APPENDIX C10e
COMMENTS AND RESPONSES REPORT

**WIND GARDEN WIND FARM, EASTERN CAPE PROVINCE
(DFFE Reference No.: 14/12/16/3/3/1/2314)**

COMMENTS AND RESPONSES REPORT

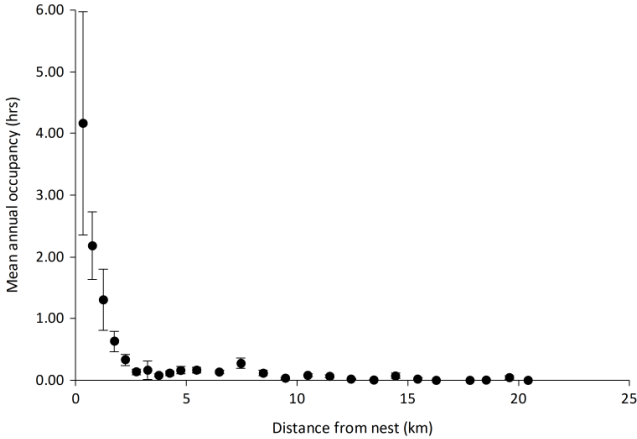
<p>Avifaunal impacts</p> <p>28. AVISENSE previously peer-reviewed the avifaunal studies for the proposed Wind Garden and Fronteer WEFs and provided detailed comments on those studies. AVISENSE was unable to complete a subsequent review</p>		<p>X</p>		<p>Comments regarding the avifaunal study were previously provided by Dr Jenkins on the draft BAR (dated May 2021) via Mr Summers and were addressed in the CRR included in the BAR (refer to page 122 and Appendix C9b for the specialists' response).</p>

<p>30. The large eagle nest survey methods, effort and efficacy remain questionable, as do the</p>		<p>X</p>		<p>Response provided in the avifauna specialist response (Appendix C9b of the CRR) states:</p>

No.	Comment	Raised by	Previously Addressed	New Comment	Response
					<p>consistently lower. Any exclusion of turbines beyond 2.5km would be of much less benefit in reducing collision risk. A similar result was found for the Choje East Block, though there, higher flight activity was noted within 1.5km of the nest (though with a smaller amount of baseline data available a precautionary approach was adopted and a 2.5km applied in the East and as well as the West).</p> <p><i>Appendix 2. Figure 1. Martial Eagle flight density and distance from the nest, Choje West June 2019 - August 2020 (mean ± 95% confidence limits).</i></p>  <p>The combination of the field survey data and spatial modelling, with the collision risk assessment have shown that the impact risk for this species for the proposed site about would not be significant (which will be further ensured through the mitigation measures).</p>

No.	Comment	Raised by	Previously Addressed	New Comment	Response																																																		
					<p>Appendix 2. Figure 1. Martial Eagle flight density and distance from the nest, Choje West June 2019 - August 2020 (mean \pm 95% confidence limits).</p>

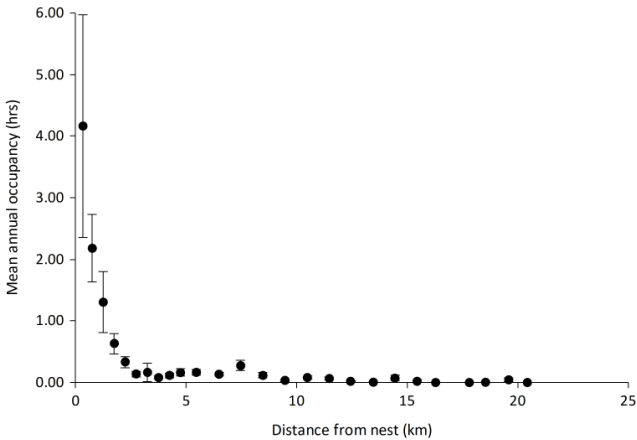
No.	Comment	Raised by	Previously Addressed	New Comment	Response
	<p>large eagle species to consider – each with markedly different habitat requirements. How do the authors propose to manage habitat to limit impacts on one species without having an adverse effect on at least one of the others...? <u>Adequate, corresponding changes made in the revised report?</u> : No</p>

No.	Comment	Raised by	Previously Addressed	New Comment	Response
	<p>Pers. comm.). This is 2.4 times the buffer used in the Barkhuysen & Percival study. In combination, imposition of these more appropriate buffers around Martial Eagle nests, based on data-rich analysis of tracked birds in comparable habitats, would substantially reduce the space available for turbine placement in the Frontier development area (Table 1, Fig. 5 vs Fig. 6).</p> <p><u>Adequate, corresponding changes made in the revised report? : No – no response at all</u></p>				<p>development from the same amount (but not shape) of area. For an equal level of eagle protection, our model can make c. 20%–21% more area available for wind energy development compared to a circular buffer."</p> <p><i>If the Verreux's Eagle Risk Assessment Model can be made available, we would be pleased use it to help inform the assessment for this species. Unfortunately, the paper as published describing that model does not include sufficient detail to be able to replicate it without further information on the model parameters.</i></p> <p><i>What is clear, however, is that even adopting very wide buffers, the collision risk to eagles is not removed and that a residual collision risk will remain. That will remain the case however much modelling and analysis is carried out, as both Murgatroyd et al's work and our own local studies have shown that these birds range widely from their nests. Avoiding the close proximity to nests can reduce the risk, but not remove it altogether.</i></p> <p><u>Page 362:</u> <i>This follows on from the same principle as above, where Murgatroyd et al highlighted the limited benefit of simple circular buffers and their inefficiency in defining areas of higher collision risk, as birds (such as Martial Eagle) do not randomly move around a specific distance from their nests but choose to forage and fly over specific areas and habitats within their range. The specialist's spatial modelling has shown the importance of distance from the nest, but also altitude (higher flight activity in the 600-800m range),</i></p>

No.	Comment	Raised by	Previously Addressed	New Comment	Response
					<p><i>distance from ridge lines (higher closer to ridge lines), and slope (higher in areas of steeper slope).</i></p> <p><i>In relation to the design of the site buffers, the analysis used to inform the 2.5km distance for Martial Eagle, for example, is set out in Appendix 2. Figure 1 from that appendix is reproduced here as it illustrates the evidence base for the use of that specific distance. The survey data showed a strong relationship between flight density and distance from the nest, but this relationship flattened out beyond 2.5km. The highest densities were recorded within 500m of nests and there was a steady decline in flight density with distance from the nest, but only up to a distance of 2.5km. Beyond 2.5km flight density was consistently lower. Any exclusion of turbines beyond 2.5km would be of much less benefit in reducing collision risk. A similar result was found for the Choje East Block, though there, higher flight activity was noted within 1.5km of the nest (though with a smaller amount of baseline data available a precautionary approach was adopted and a 2.5km applied in the East and as well as the West).</i></p>

Figure 1: Wind noise spectra by third-octave bands, measured in a wind tunnel (Z-weighting)

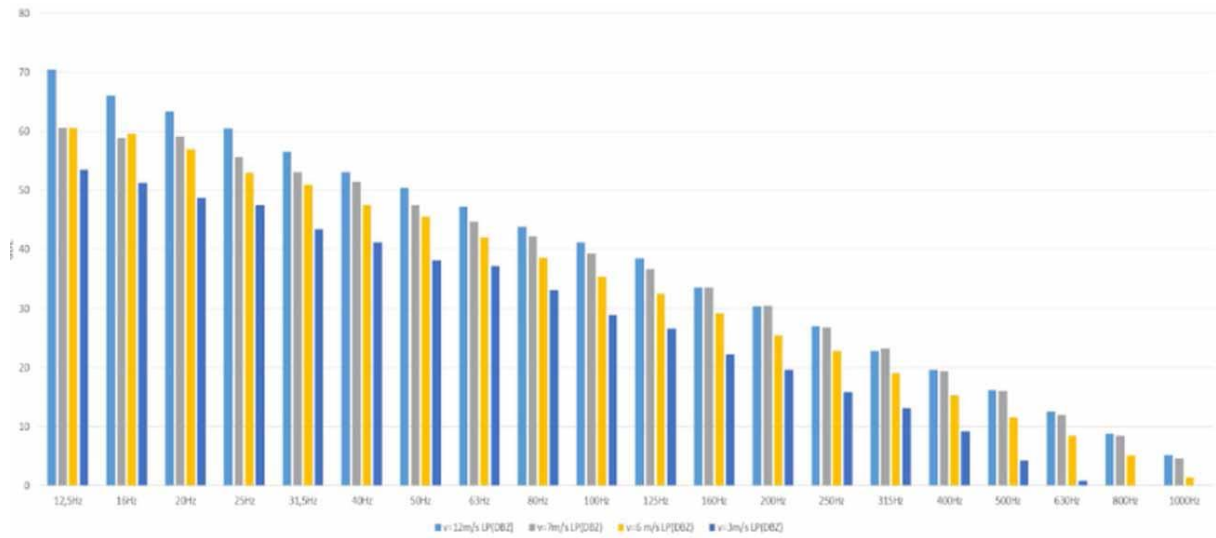
The problem is that wind itself contain significant acoustic energy in the lower frequencies. This is illustrated in **Figure 1** below as reported by Gianoli (2016).

Figure 2: Processed data for the WindRelic projects, considering frequencies 20 – 20,000 and 20 – 160 Hz

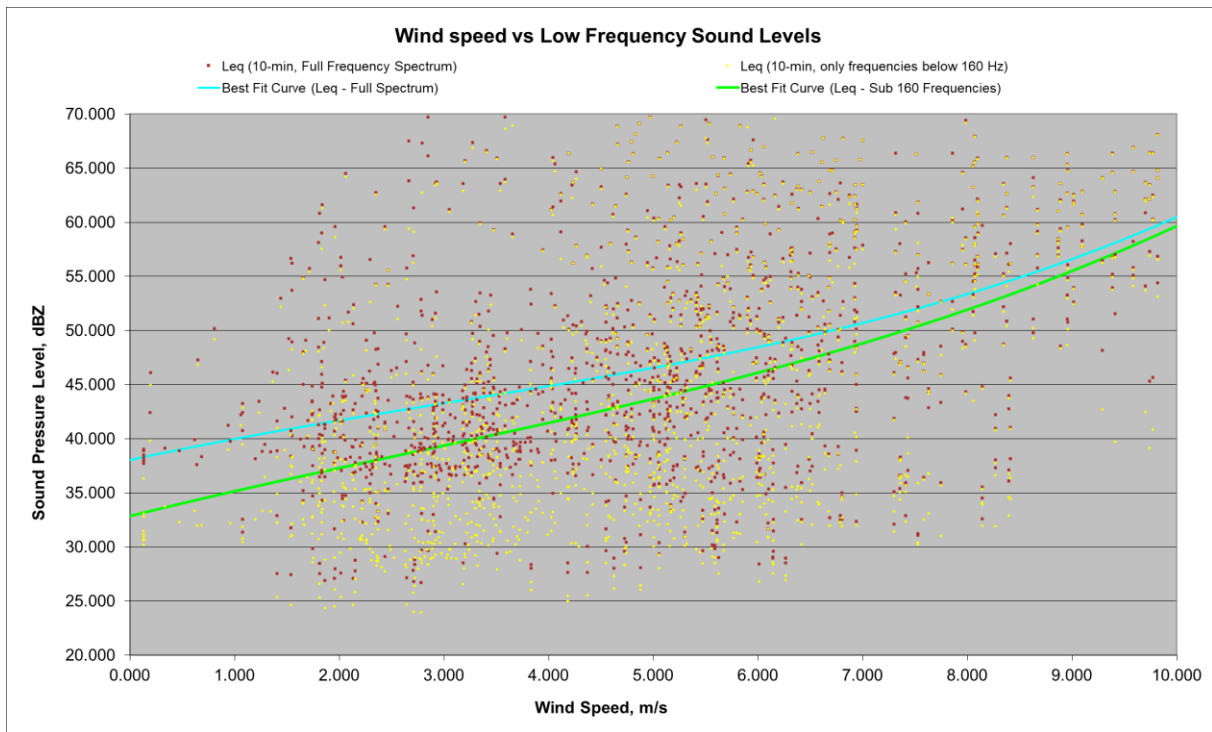
The author has also measured a similar curve, with most of the acoustic energy located in the lower frequencies, at most measurement locations (during periods with increased winds). It should however be noted that the measurements were done as per SANS 10103:2008, with most instruments rejecting frequencies below 20 Hz. As the author also measured the spectral data for the WindRelic projects, LFN can be calculated and processed as illustrated in **Figure 2** (Database of author).

Because this graph only considers the frequencies higher than 20Hz, a significant portion of acoustic energy is not accounted. When one evaluates the data from an instrument that measure and report data down to 12.5 Hz, see also **Figures 3 and 4** (database of author), it is easy to see that the quantity of LFN in the environment is significant.
